Model type:
WITL85EU

Commercial code:
F034280

1140960 Exploded views

n1040345: Replacement of drum lock button TL EVOII.

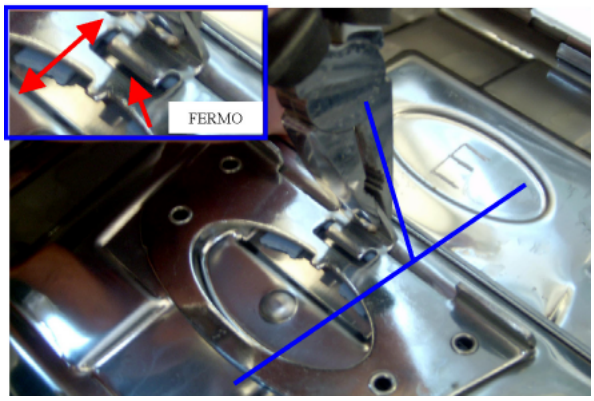
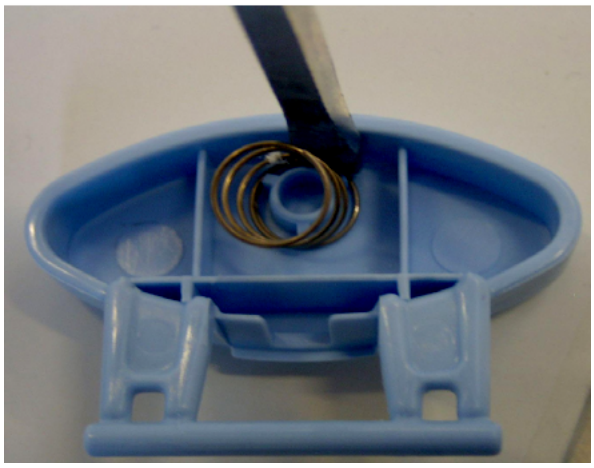
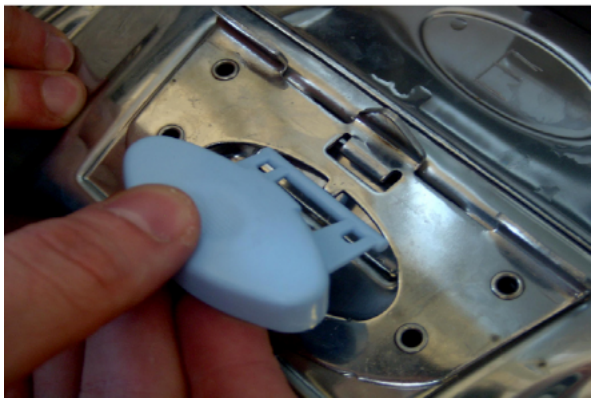
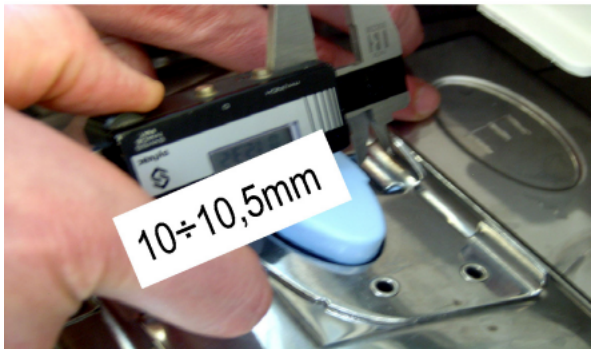
Tools and material needed: pliers, screwdriver, gauge, spring P/N Sat 114989, button P/N Sat 114990.

1) turn the central tip of the catch in the direction shown (FIG.1);

2) bring the tip to a vertical position and ensure that the broken button is disengaged from the catch restraint and can be removed (FIG.2);

3) remove the remaining part of the button with the aid of a screwdriver, taking care not to scratch the doors (FIG.3);

4) pre-assemble spring to button (FIG.4);

5) insert button between catch and door (FIG.5);

6) bring the button into position and arrange the spring in its location in the door (FIG.6);

7) turn the central tip of the catch in the direction shown to return it to its starting position (FIG.7);

8) check the distance between button and catch (FIG.8);

9) check correct operation of the button when opening and closing the doors (slight inclination errors of the catch can result in

faulty closing of the doors) (FIG.9).

n1040382: Drain pump with bayonet-style filter - top Loading Brembate

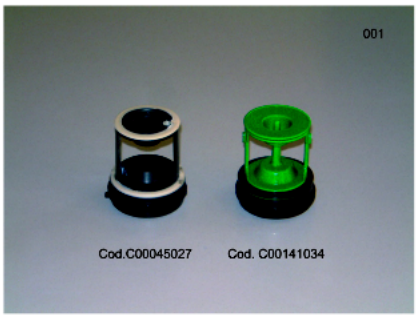
From serial no. 51021.0001 a new drain pump with bayonet-style filter has been installed on all top loading washing machines manufactured in Brembate.

New parts:
C00141862 - Drain pump
C00141034 - Pump filter kit

Premodification parts:
C00111409 - Drain pump
C00045027 - Pump filter kit

The new parts can be used instead of premodification ones.

N1040404FIG1

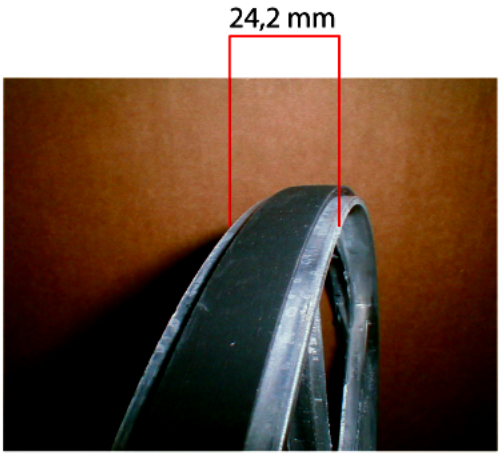
From serial no. 51202.0001 the pulley track has been widened from 21.2mm to 24.2mm (see picture N1040404FIG1).

new pulley
C00142832 - D280 24.2 mm track

Premodification pulley
C00083912 - D280 21.2 mm track

The new pulley can also be used on premodification versions of the models referred to in this release.
